DESCRIPTIVE REPORT

Registry No. W00093 -W00098, W00113

General Locality Saipan Island

Sublocality Saipan Harbor and Approaches

Figure 2: Garapan channel. Red text show NAVO positioned aids to navigation.

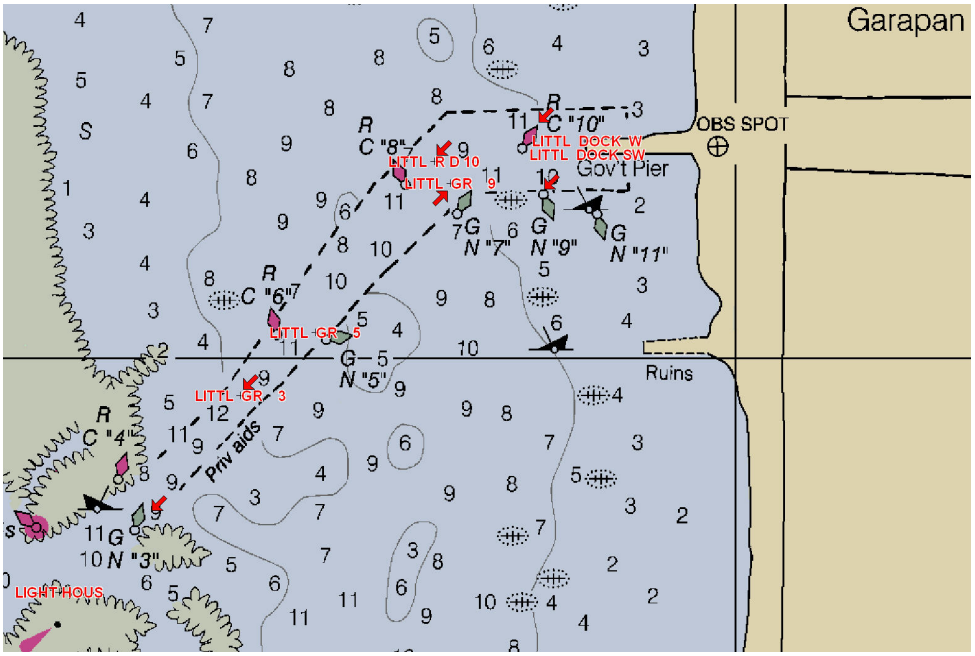
Several charted (81076) private aids to navigation in the approaches to Garapan (15°12'02.68" N, 145°42'43.14" E; (361648.46, 1680937.16)) were positioned by NAVO personnel during the survey. Positioned aids to navigation varied from their charted location by up to 220 meters (green nuns 3, 5, 9 and red can 10). Additionally several charted aids were not positioned (Buoy R "2", red cans 4, 6, 8 and green nuns 7 and 11). Due to the age of information and the likelihood for repositioning, the Evaluator recommends charting these aids based on the latest information from the Coast Guard. [37]

Figure 4: Two charted (81076) wrecks

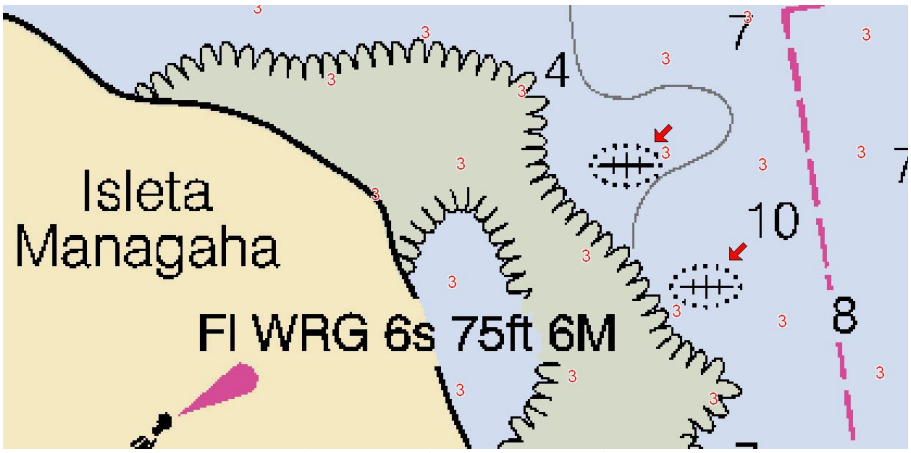
Two charted (81076) wrecks at 15°14'29.06" N 145°42'54.74" E and 15°14'31.28" N 145°42'53.18" E were covered by 200% LIDAR. NAVO personnel did not see any evidence of the wrecks when reviewing the PFM, but did note coral heads in the area. The Evaluator conducted and independent review of the full density sounding data and did not find any indication of the wrecks. Depths at the charted positions of the two wrecks were three feet. The Evaluator recommends retaining the two charted wrecks, for reasons stated in section D.2, complicated by the ability of LIDAR to definitively detect such features in the presence of an irregular seafloor (coral) in the search area.[39]

Figure 5: Charted (81076) wreck

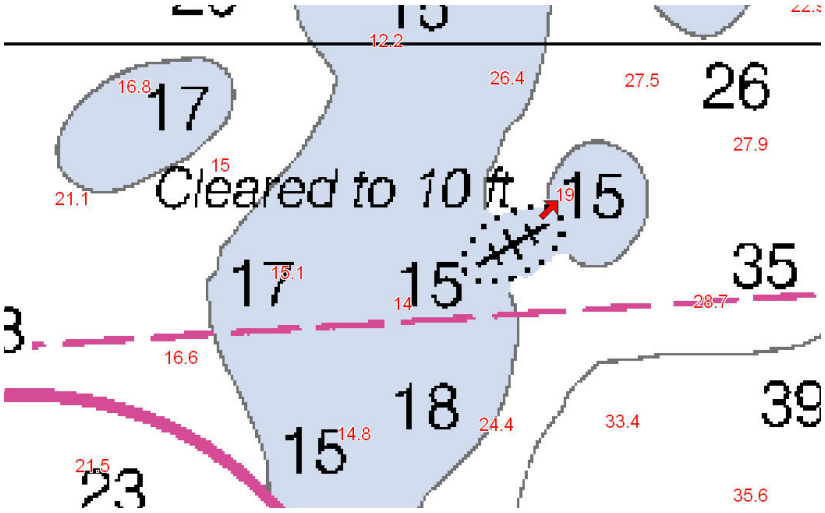
The charted (81076*)* wreck at 15°13'57.32" N 145°43'18.39" E was covered by 200% LIDAR. NAVO personnel did find evidence of the wreck through review of the PFM, at 15°13'57.92" N 145°43'19.06" E. The least depth on the wreck was 19 feet. The Evaluator conducted an independent review of the PFM, and agrees with the NAVO assessment. The Evaluator recommends retaining the wreck as charted, including the "Cleared to 10 feet" note. The surveyed least depth should not be charted for reasons stated in section D.2 with regard to

the ability of LIDAR to definitively determine a least depth.[40]

Figure 6: Charted (81076) wreck

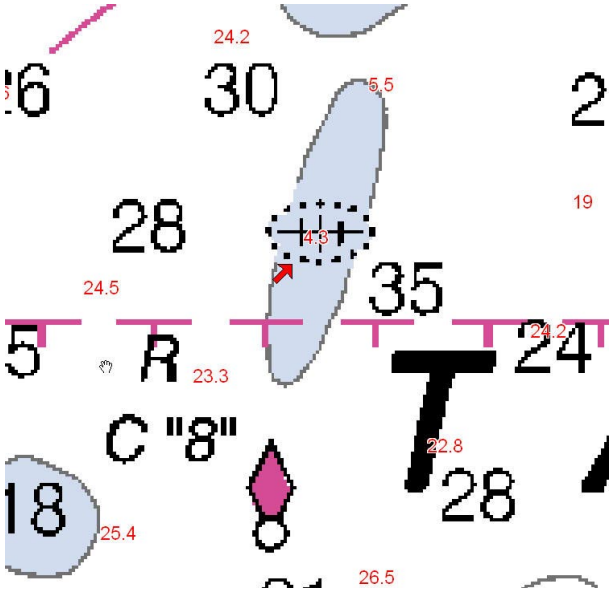
The charted *(81076)* wreck at 15°14'09.09" N 145°43'27.65" E was covered by 200% LIDAR. NAVO personnel did not conduct an evaluation of this feature. The Evaluator did conduct a review of the PFM, and saw evidence of the wreck at its charted location. A least depth of 4.3 feet was found at the charted location. The Evaluator recommends retaining the wreck as charted, without a least depth.[41]

Figure 7: Two charted (81076) wrecks

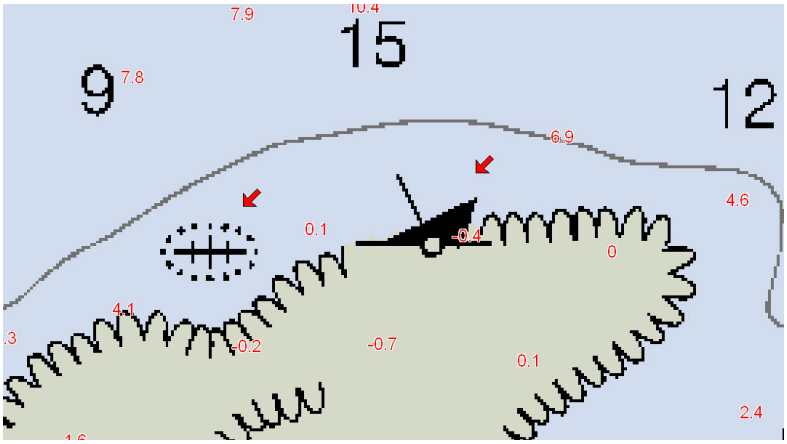
Two charted (81076) wrecks at 15°13'31.71" N 145°42'34.45" E and 15°13'31.87" N 145°42'37.57" E were covered by 200% LIDAR. NAVO personnel did not see any evidence of the wrecks when reviewing the PFM. The Evaluator conducted an independent review of the full density sounding data and did not find any indication of the wrecks. Depths at the charted positions of the two wrecks varied from -0.4 to 4.1 feet. The Evaluator recommends

retaining the two charted wrecks for reasons stated in section D.2.[42]

Figure 8: Seventeen charted (81076) wrecks

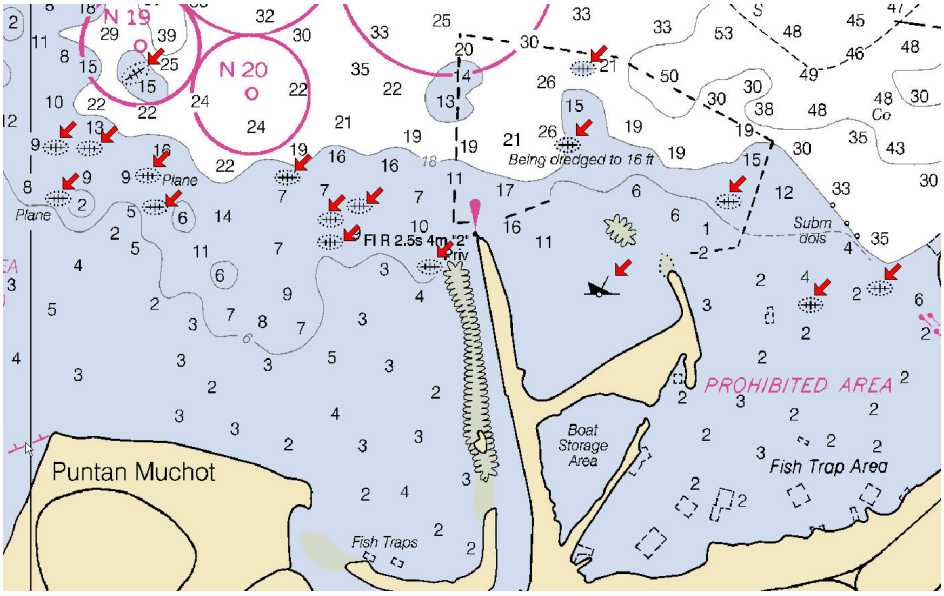
Seventeen charted (81076) wrecks centered around 15°13'22.25" N 145°43'23.23" E north of Puntan Muchot were covered by 200% LIDAR. NAVO personnel did not see any evidence of the wrecks when reviewing the PFM. The Evaluator conducted and independent review of the full density sounding data and did find evidence of one wreck, as well as numerous coral heads. The Evaluator recommends retaining the seventeen charted wrecks for reasons stated in section D.2.[43]

Figure 9: Twenty-three charted (81076) wrecks

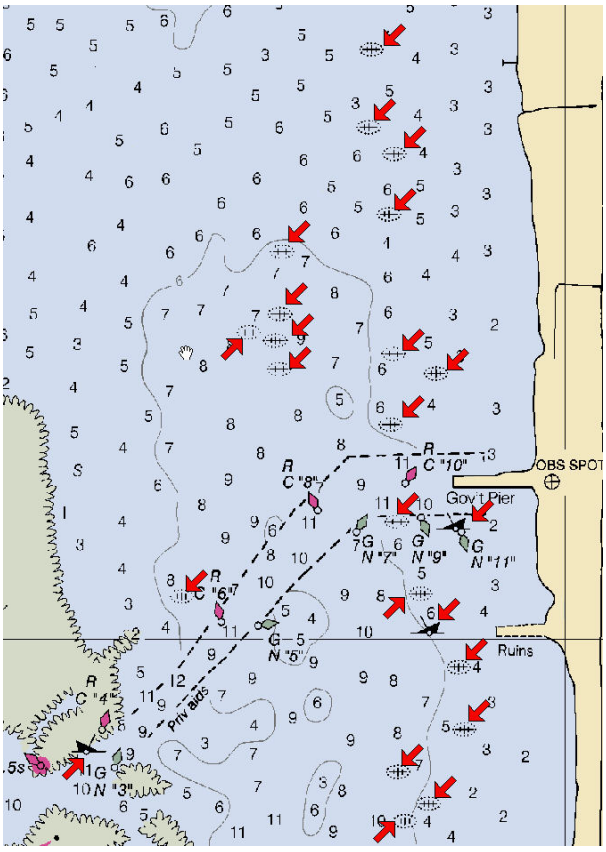
Twenty-three charted (81076) wrecks off Garapan government pier (centered at 15°12'08.77" N 145° 42'53.83" E) were covered by 200% LIDAR. NAVO personnel saw evidence of one possible wreck at 15°11'53.83" N 145°42'32.74" E when reviewing the PFM. The least depth was reported as 4 feet. The Evaluator conducted and independent review of the full density

sounding data and confirmed the possible wreck, at the above position as well as numerous coral heads. The Evaluator recommends retaining all charted wrecks, for reasons stated in section D.2.[44]

Figure 10: Charted (81076) unexploded ordnance

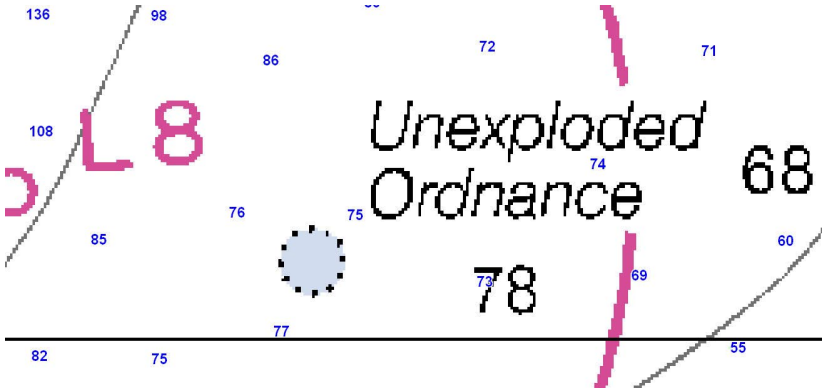
The charted unexploded ordinance (15°14'01.17" N 145°41'24.13" E on chart 81076 and 15°14'01.11" N 145°41'25.76" E on chart 81067) in charted Naval Anchorage L8 was covered by 200% LIDAR. NAVO personnel did not conduct an evaluation of this feature. The Evaluator did review the PFM, and saw no evidence of the ordnance at its charted location. Depths in the area ranged from 75-77 feet. The Evaluator recommends retaining the unexploded ordinance as charted for reasons stated in section D.2.[45]

Figure 11: Charted (81076) isolated shoals positioned during the survey

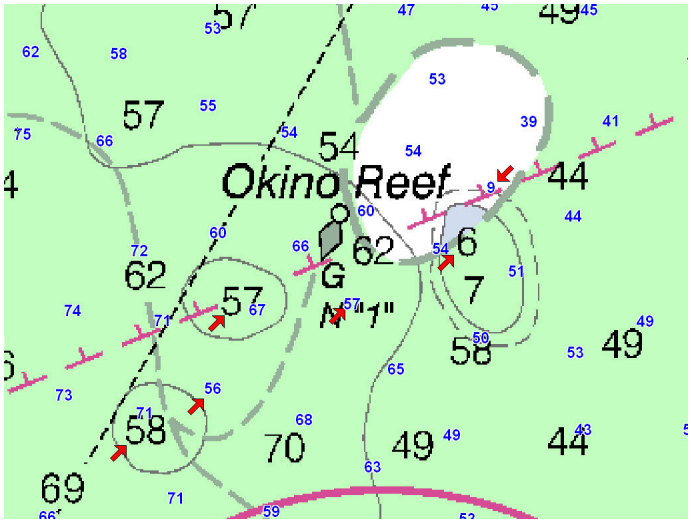
Numerous charted (81076 and 81067) isolated shoals are portrayed within the Garapan Anchorage, (centered around 15°11'44.59" N 145°41'20.68" E). This area was covered by 200% LIDAR. NAVO personnel did not conduct an evaluation of these features. The Evaluator conducted a review of the PFM, and observed the charted shoals; however many appeared to differ from their charted location. The Evaluator recommends retaining the charted shoals and also recommends charting new shoal soundings based on the survey.[46]

Figure 12: Charted (81076) isolated shoals positioned during the survey

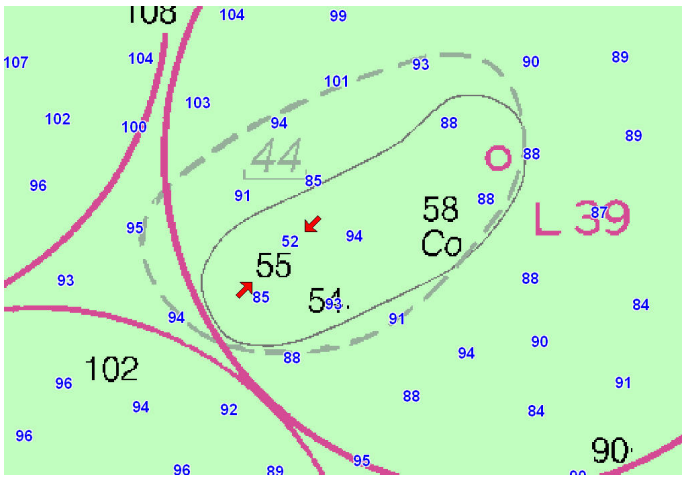
The charted (81076) shoal at 15°11'50.37" N 145°40'46.27" E ; (358158.55, 1680579.73) was covered by 200% LIDAR. The charted shoal is depicted as being approximately 290 meters by 100 meters. The survey detected a single isolated feature with a least depth of 53 feet at 15°11'50.79" N 145°40'44.61" E; (358108.99, 1680592.97). Review of the PFM did not indicate any other shoaling in the area aside from the single sounding. The Evaluator has confidence that LIDAR would have detected the presence of a feature the size of the charted shoal. Because the LIDAR least depth is shoaler than the chart, the Evaluator recommends charting the area based on the NAVO survey and retaining other charted shoal soundings in the area. [47]
